City of Kingston
Report to Kingston Heritage Properties Committee
Report Number HP-24-043

Subject: Applications for Ontario Heritage Act Approval

Address: 411 Wellington Street (P18-520)

File Numbers: P18-095-2024, P18-096-2024, P18-097-2024, P18-098-2024, P18-099-2024 and P18-101-2024

FRONT ELEVATION

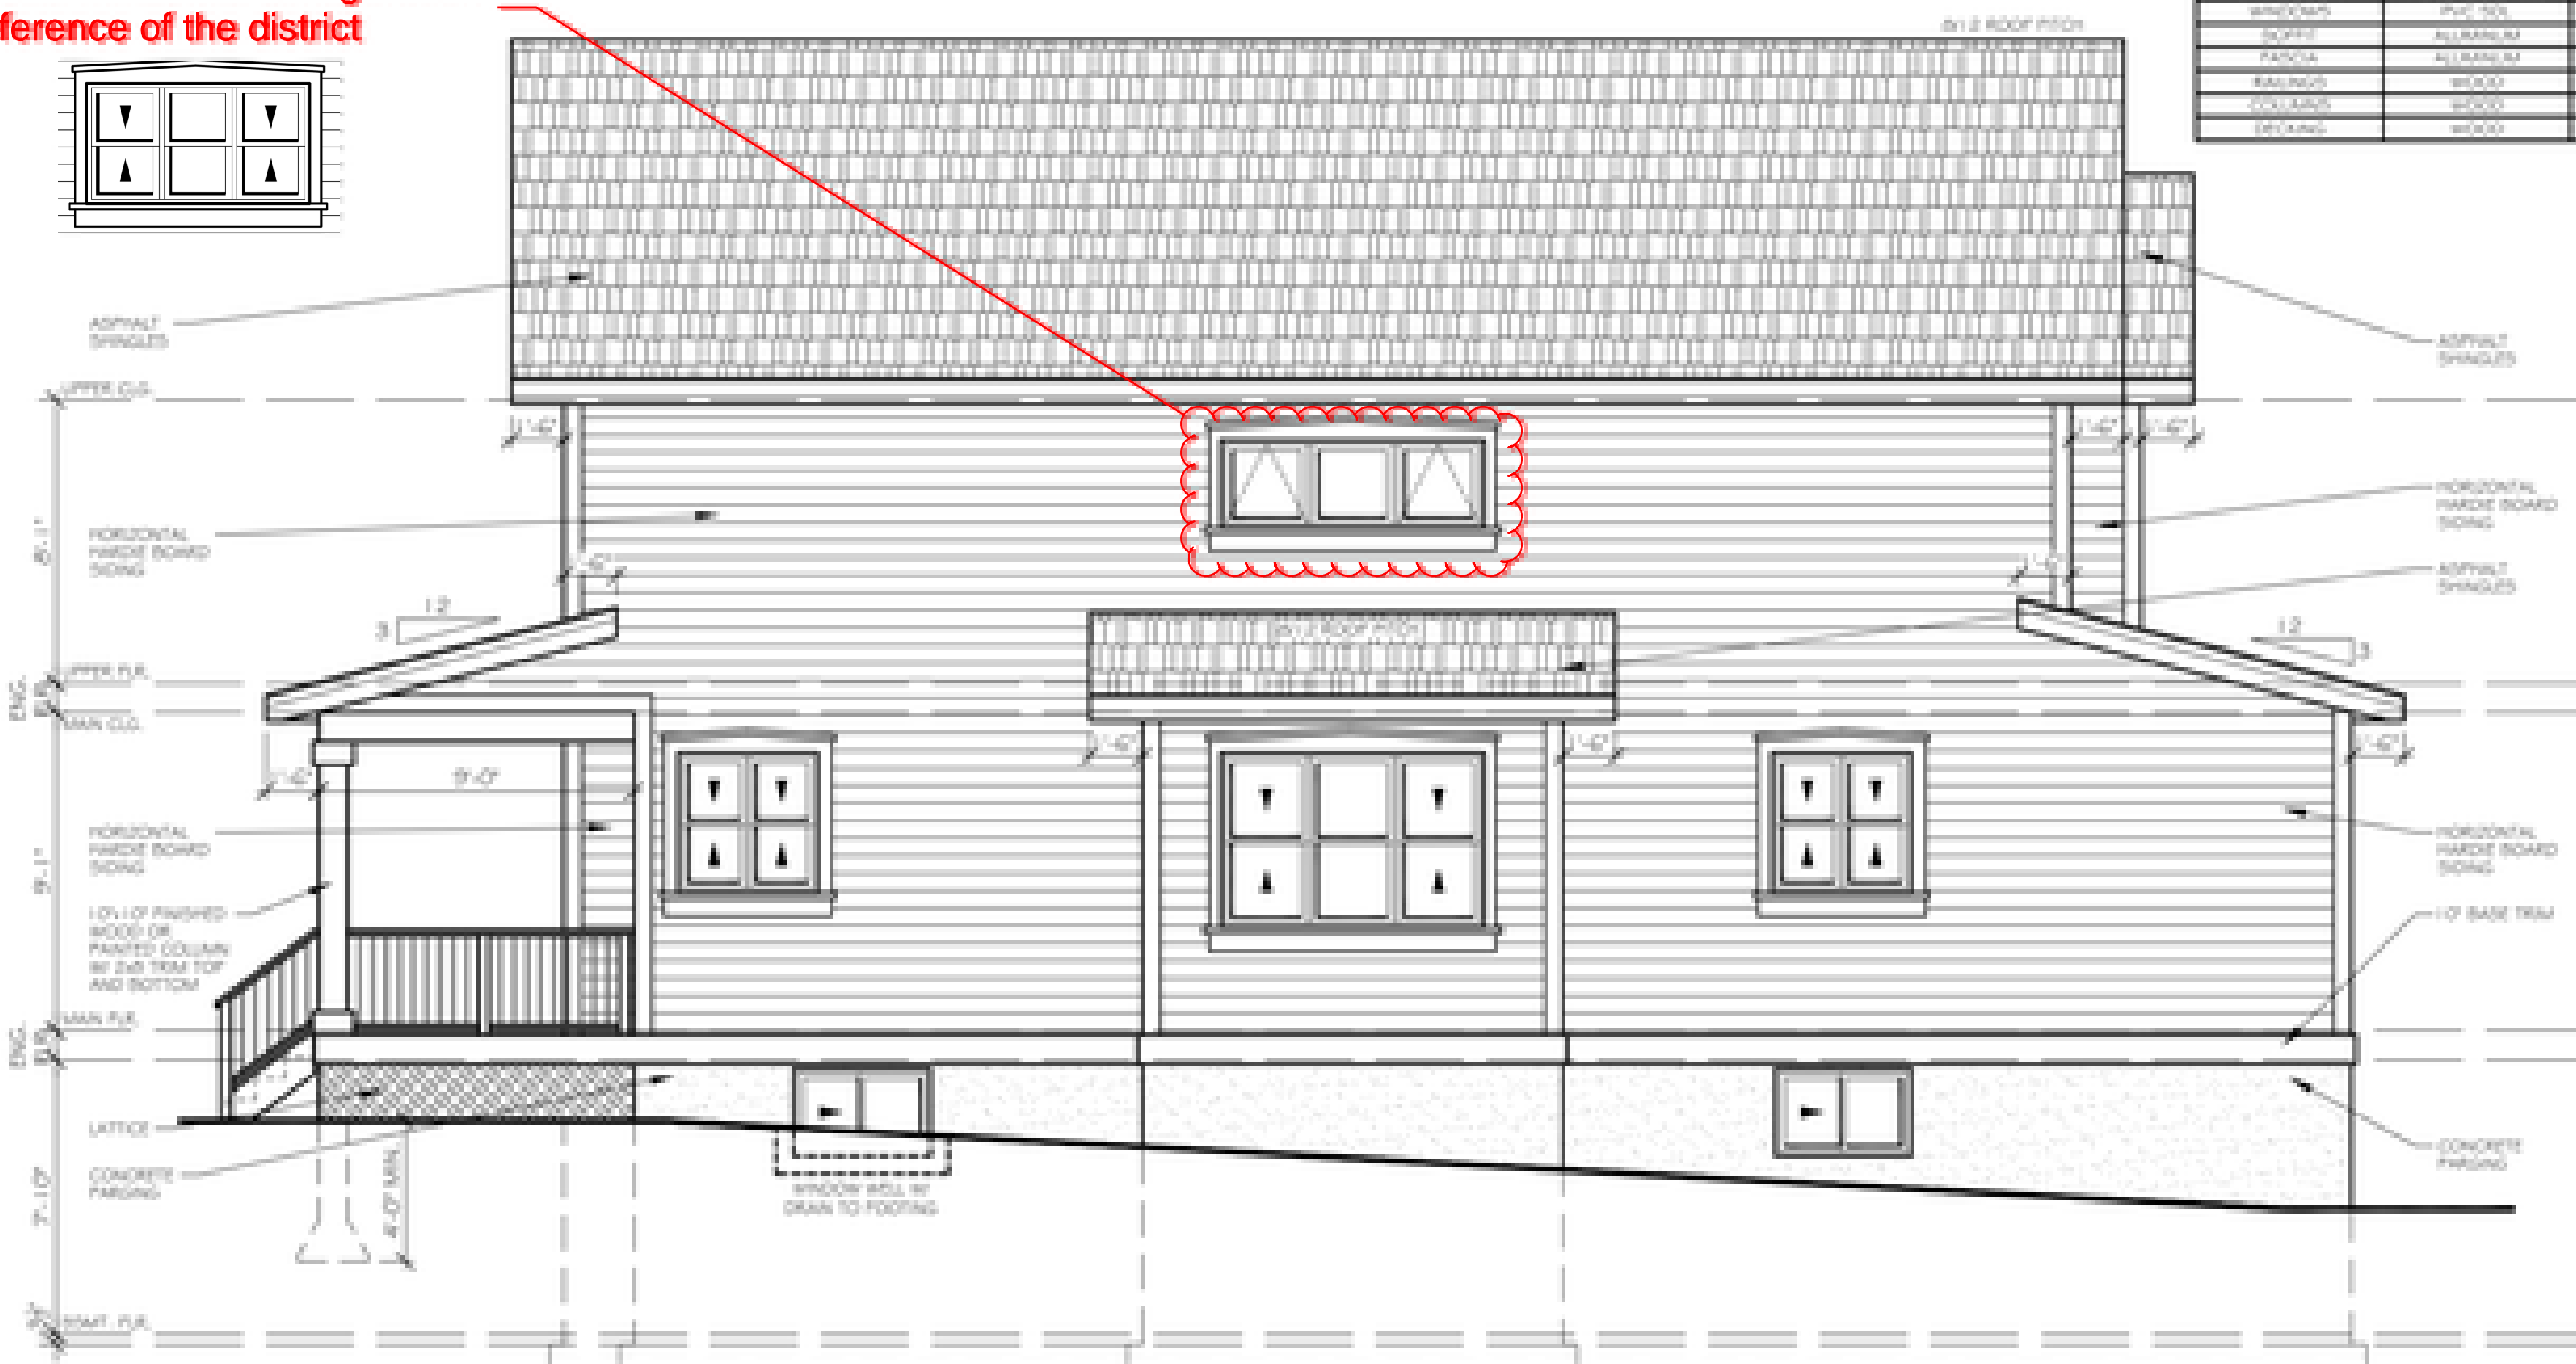
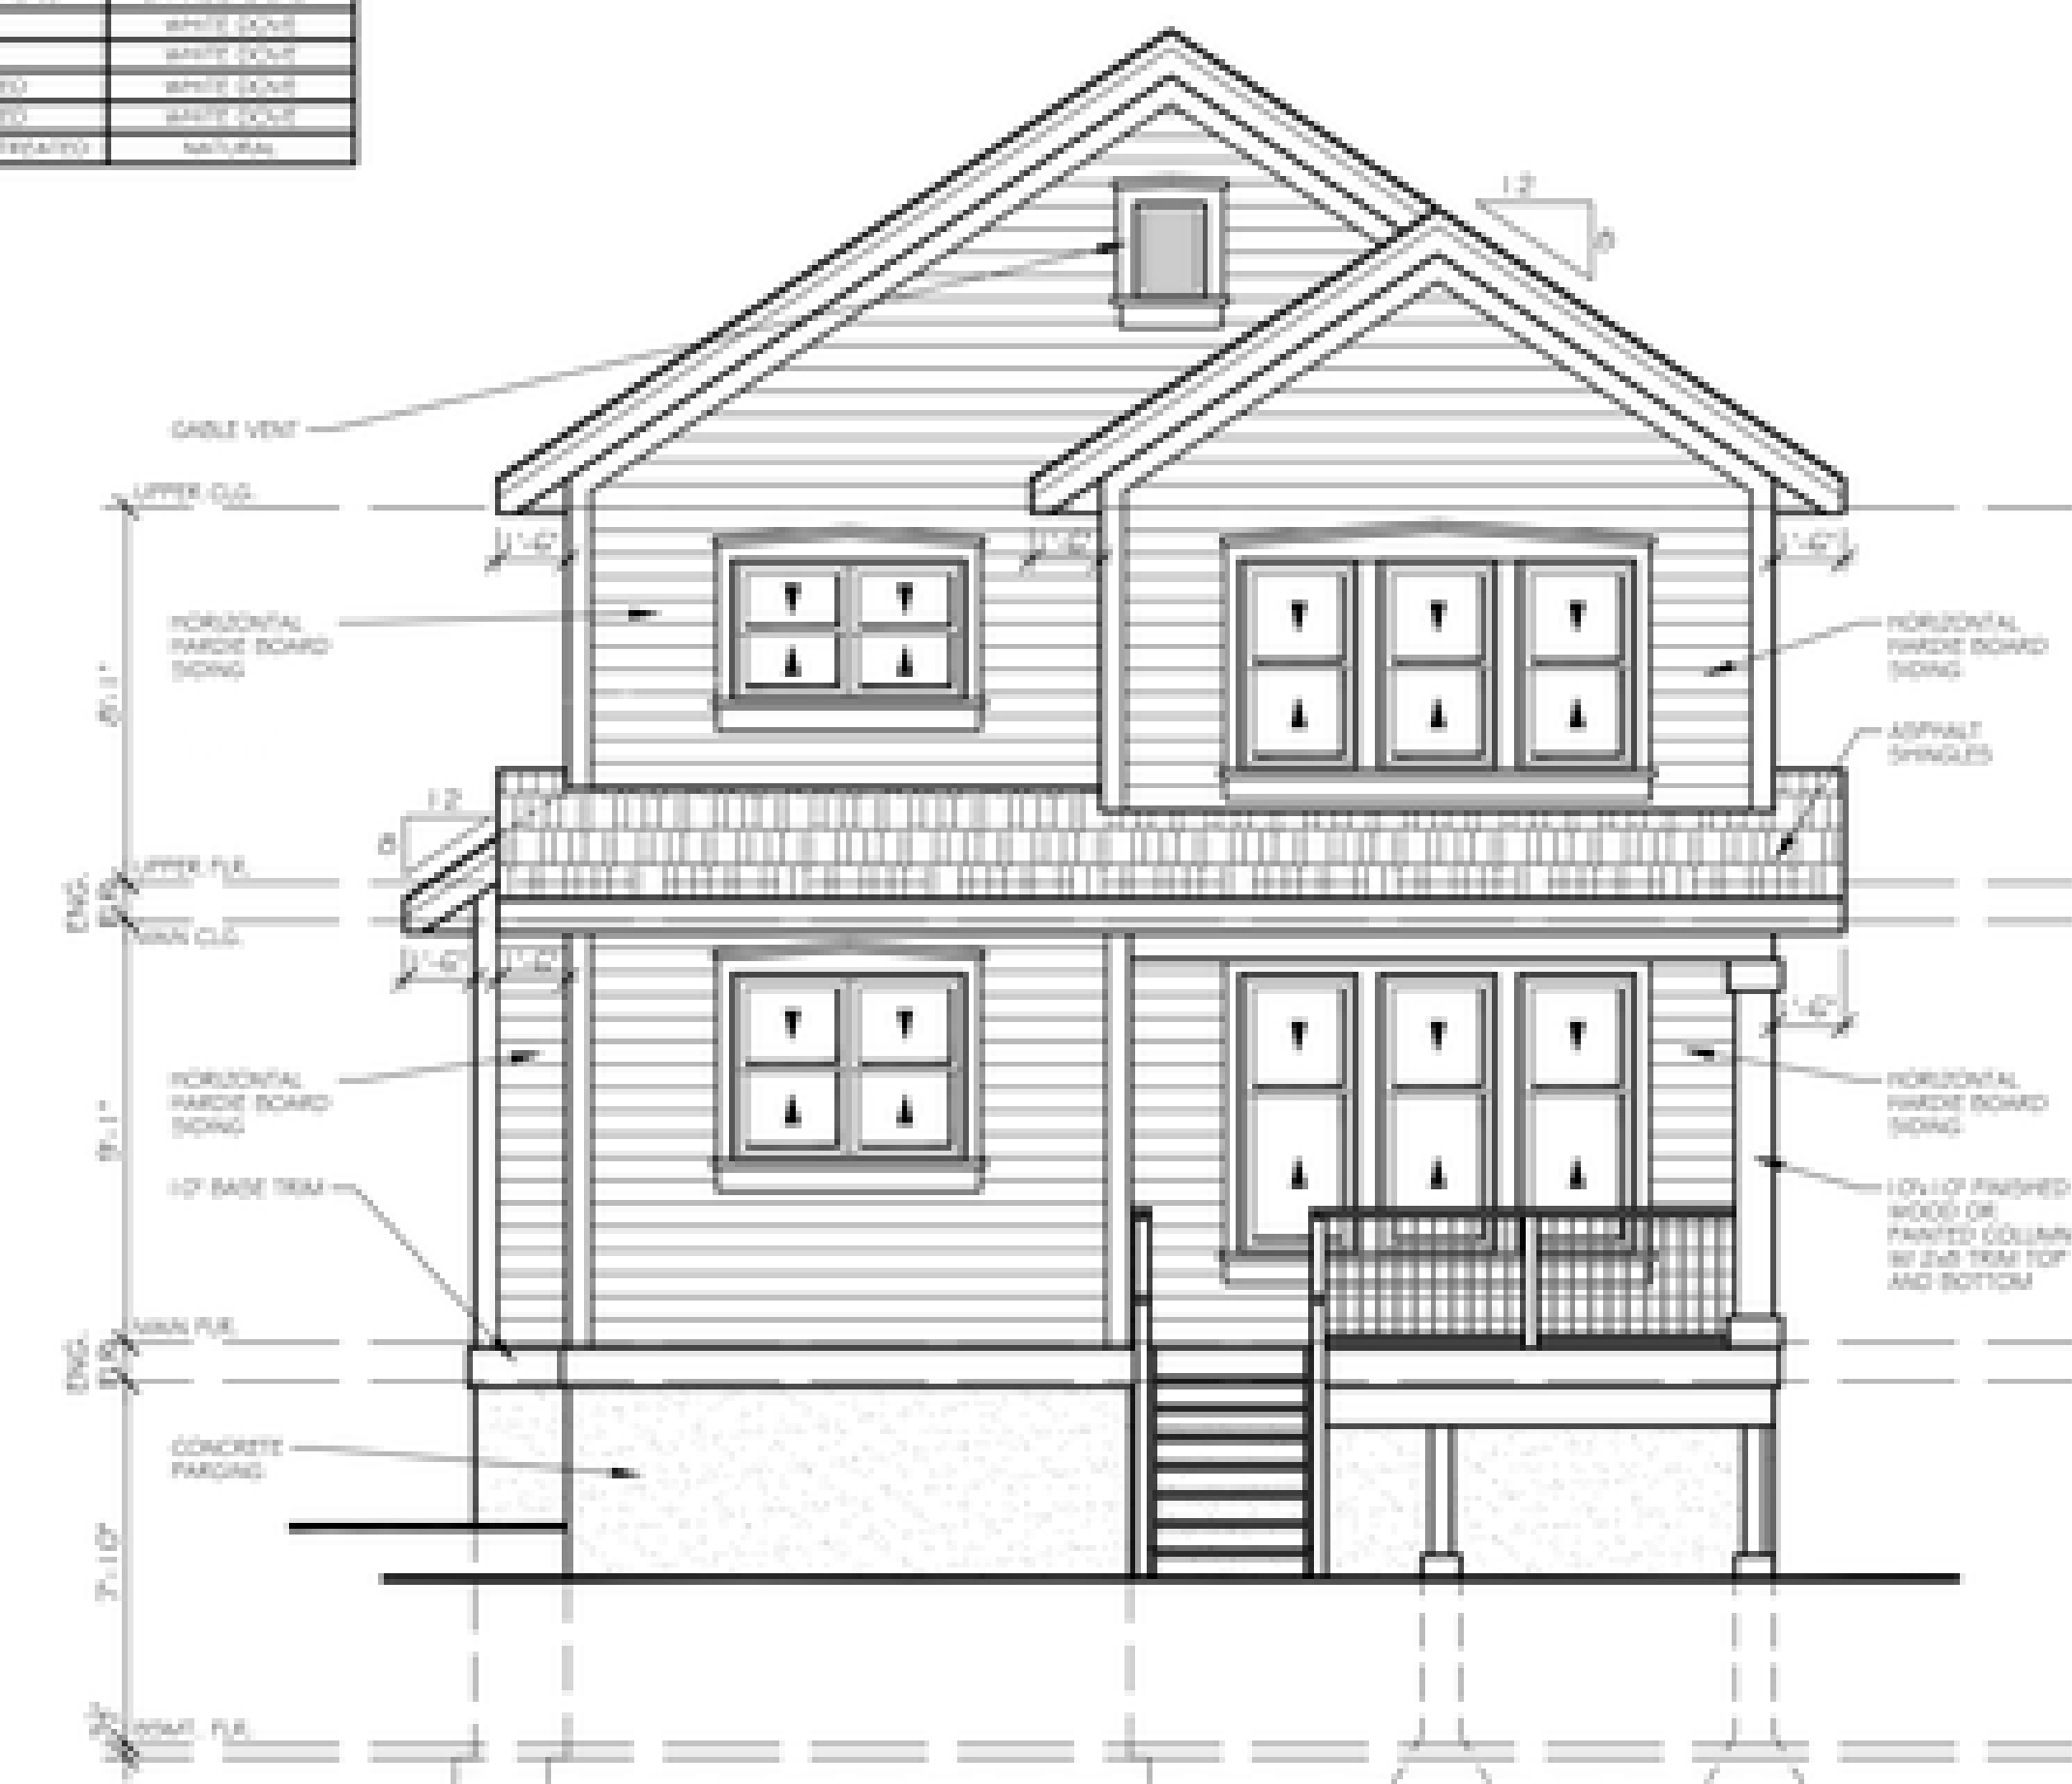
Change to reflect the prominent
vertical horizontal configuration
preference of the district
